**Amendments to the Statewide Urban Design and Specifications (SUDAS)
Design Standards Manual and Specifications Manual by the City of Tiffin**
Approved Date: April 4, 2017

The Statewide Urban Design and Specifications (SUDAS) Design Standards Manual shall be adopted with the following amendments:

2.) Figures G-1.02 and 2G-1.03 show typical installation details.

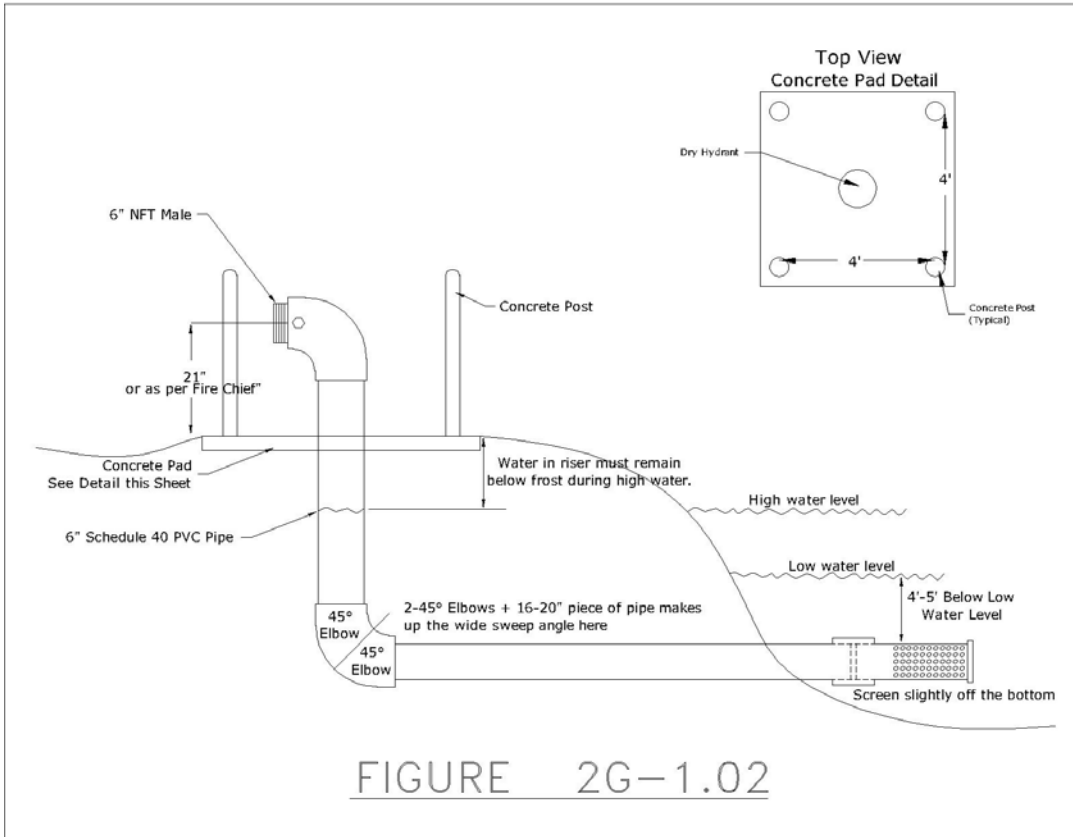
a. Dry Hydrant Installation

1.) All wet-bottom detention facilities shall have an emergency vehicle accessible dry hydrant installed. Additional information regarding installation is available at the Office of the City Engineer. All dry hydrants installation sites will be approved by the Fire Chief and construction drawings will be approved by the Fire chief and City Engineer.

Add figure 6010.308

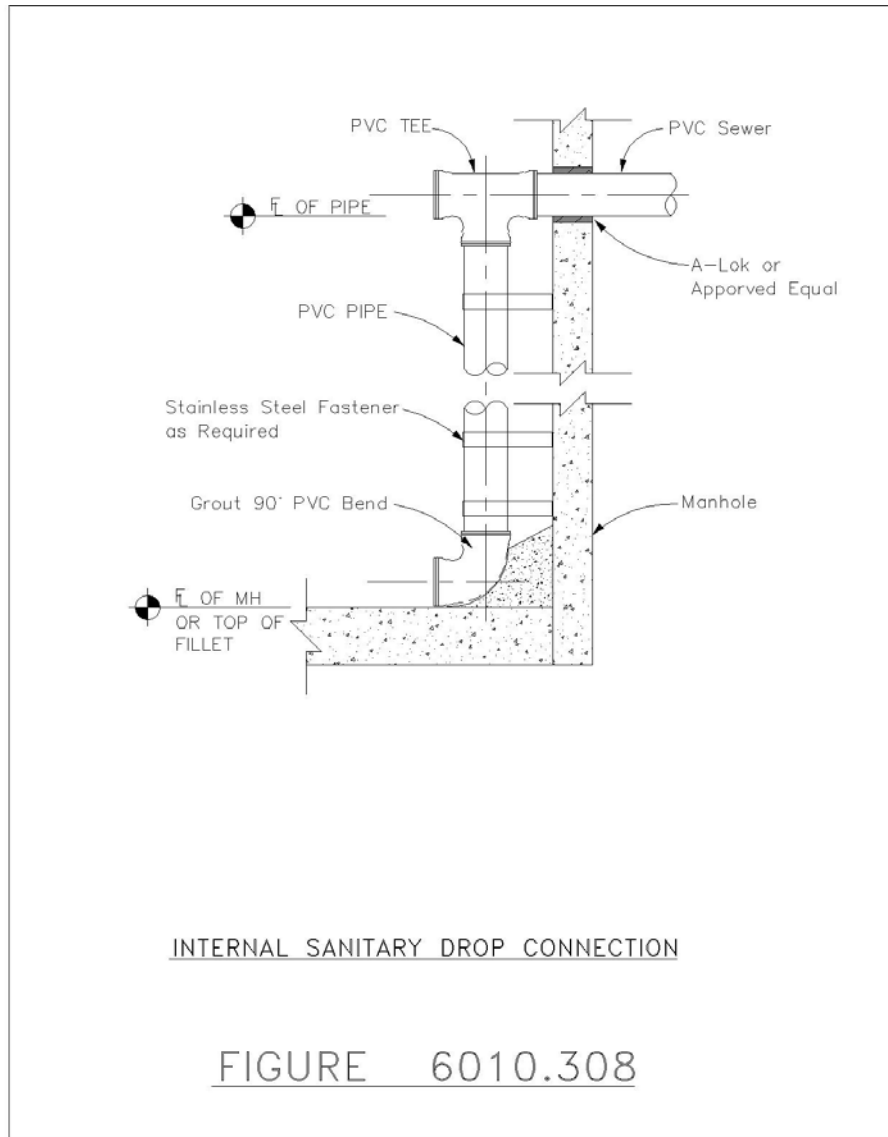
1.08. A.3. Each type of Chimney Seal will be counted by the Engineer. Payment will be at the unit bid price for each type of Chimney Seal installed. Unit price includes but is not limited to furnishing all equipment labor and materials necessary to install the type of Chimney Seal per manufacturer's recommendations and as shown on the Plans.
